City of Santa Fe

Plan Number: 2021-004608--HDRB

Project Description: Primary Facade Designation

Project Location(s): 964 ACEQUIA MADRE
Santa Fe, NM 87505

Figure 1: 1984 HBI survey photograph (above) compared with recent image of Front (north) elevation.

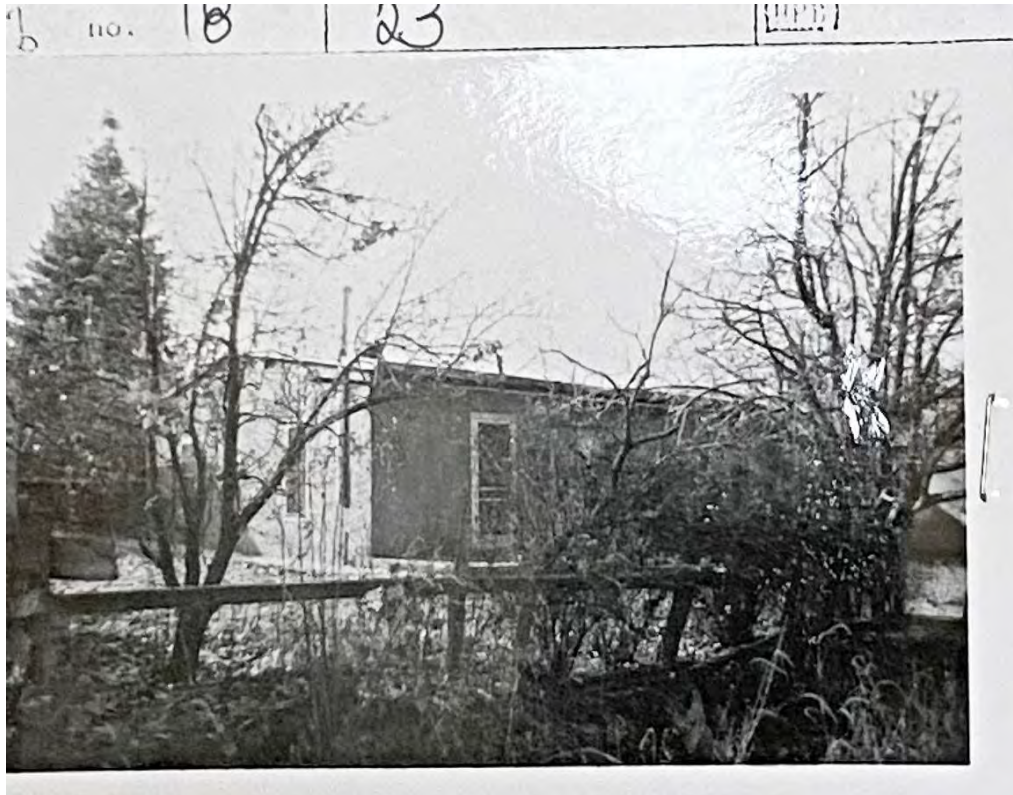
Most pertinent to your research is a case from 1994 (H#94-152). Presented on September 12, 1994, the application proposed a new north "portal" and yard wall. Communication with the project's architect confirmed that it received approval with the porch constructed soon after.³ This addition is evident when comparing the 1984 survey photo to the current facade (Figure 1).

Comparing the two images in Figure 1, it is evident that the front door shifted to the west between 1984 and the present. Additionally, it seems the roof's north pitch may have changed in angle and height. This may reflect work that came following HDRB review. However, without complete records, it is not possible to determine the origin of these alterations.

Chair Rios said the photo in the packet from John Murphy shows the house prior to porch construction. John Murphy indicated the door was moved to the west but after studying the photographs, she disagreed. She thought the photographs were taken from different angles and the door has not been moved. She could see a reflection of the light from the windows in the old photograph and why would someone move the door a few inches.

Chair Rios referred to the bottom picture where the house appeared longer. She thought the photos were taken from different angles.

Christopher Purvis, 518 Old Santa Fe Trail was sworn. He said he and John had discussed this door at length. He said he used a graphic trick and turned the top photograph on its side. The door appeared to go past the end of the building. When doing the same thing on the lower photograph, it doesn't and looks like it has been moved 3 feet. There isn't any way to know unless the structure is tested. He noted on the back side is a heater.

FACADE DIAGRAM

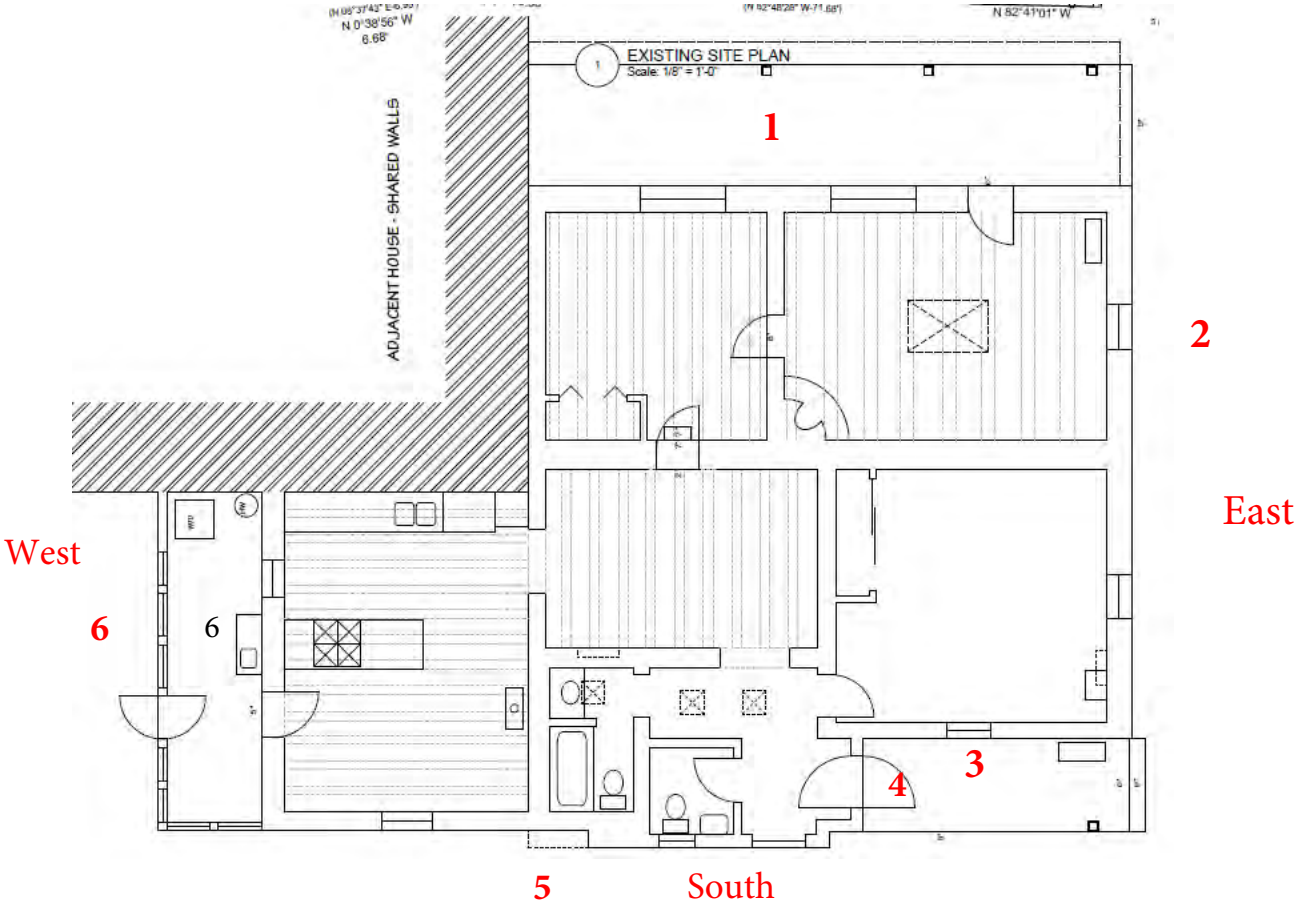
Staff recommends designating the east façade number 2 primary per 14-12 for Contributing Structures and Primary Façades.

The applicant requests designation of primary façade(s) as applicable. Staff recommends façade 2 as primary because it maintains its original massing and historic windows a. Façade 1 (front) has been significantly altered by the addition of a formal portal, changing its “simplified” Spanish-Pueblo revival style to more of a Territorial Revival style, which presents as a later addition. The house entry door is not in its original opening.

MOTION: In Case 2021-004608-HDRB, 964 Acequia Madre, Member Biedscheid moved to designate the east façade, number 2, as primary, excluding the side portion of the portal that appears on that facade, and the north façade number 1, excluding the portal and all non-historic windows, doors, or openings as to be determined by further assessment. Vice Chair Katz seconded the motion.
